To: Jim Totten, General Manager
Lost Pines Groundwater Conservation District

Subject: Review of LCRA Permit Application Packet

DBS&A has reviewed the operating permit application packet submitted by LCRA for eight wells to be completed in the Simsboro Aquifer in Bastrop County. The wells would be located on the Griffith League Ranch property, located between Lake Bastrop and the town of Paige, as shown in Figure 1 below.

Figure 1. Location of proposed LCRA wells.

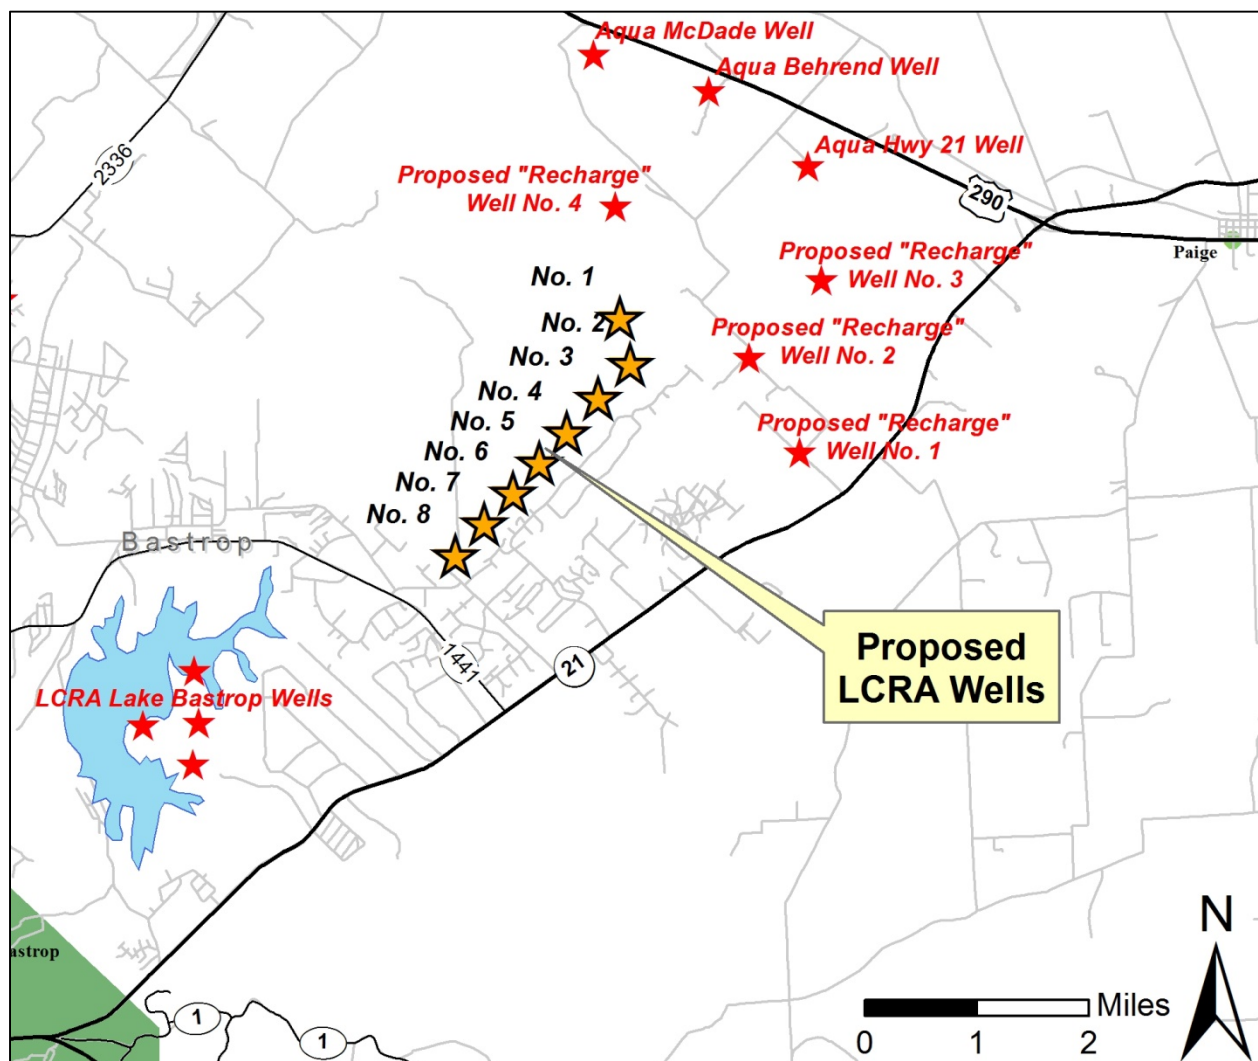
The proposed LCRA wells are located near several existing Simsboro Aquifer wells and near several proposed Simsboro Aquifer well locations in the pending Recharge Texas, LP (formerly End Op, LP) permit application. The LCRA wells are:

- as close as 5,200 feet south of the proposed “Recharge” Well No. 4 location
- as close as 5,600 feet west of the proposed “Recharge” Well No. 2 location
- as close as 11,000 feet south/southwest of three Aqua wells (McDade, Behrend, and Highway 21), and
- as close as 13,000 feet from four existing LCRA wells in their Lake Bastrop well field.

Figure 2. Project-specific 50-year drawdown (in feet) in the Simsboro Aquifer attributable to the proposed LCRA pumpage estimated using the GAM.

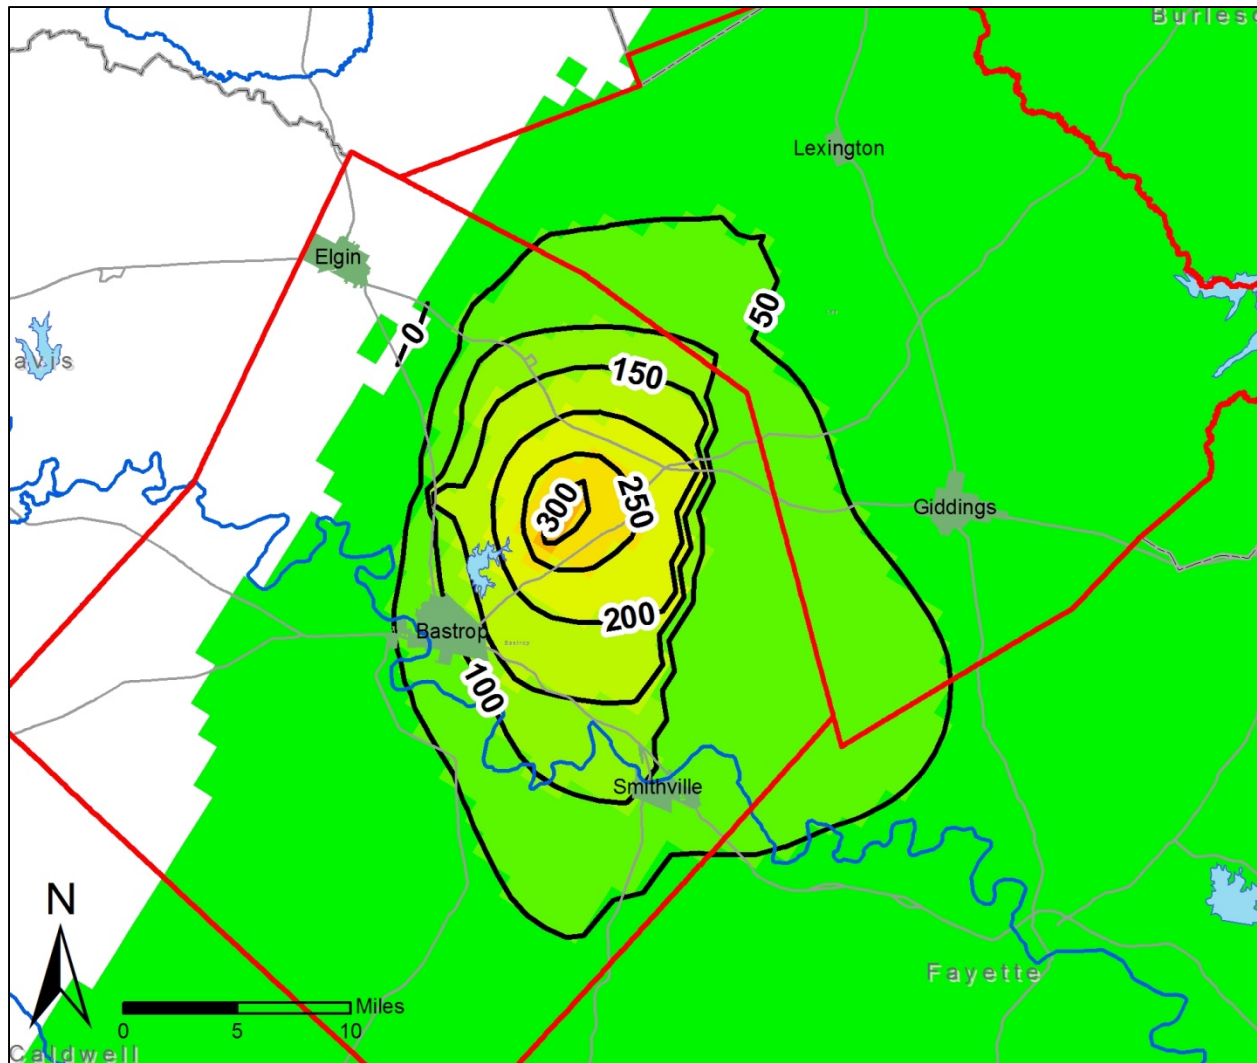
The Central Queen City-Sparta Groundwater Availability Model (GAM) was run with the proposed pumpage added in the model cells in which the proposed wells are located. A map of project-specific drawdown estimated using the GAM is shown in Figure 2, and a close-up map of the project-specific drawdowns using the GAM is shown in Figure 3. The model run results indicate that at the end of 40 years of pumping (in 2060), the project-specific drawdown (drawdown due to the proposed LCRA wells only) is as follows:

- approximately 225 to 250 feet at the three Aqua well locations (McDade, Behrend, and Highway 21).
- approximately 250 to 275 feet at the proposed “Recharge” (End Op) well locations.
- approximately 160 to 180 feet at the existing LCRA wells near Lake Bastrop.

These drawdown estimates are an approximation obtained using the regional-scale GAM, which may not account for local hydrogeologic conditions. However, it is reasonable to conclude that the pumpage from the proposed LCRA wells will result in approximately 200 or more feet of drawdown at nearby permitted wells and the proposed permitted well locations by the year 2060. This model run was completed in the same manner as previous model runs conducted to evaluate permit evaluations requested by the Board, so that a direct comparison to previous model runs can be made.
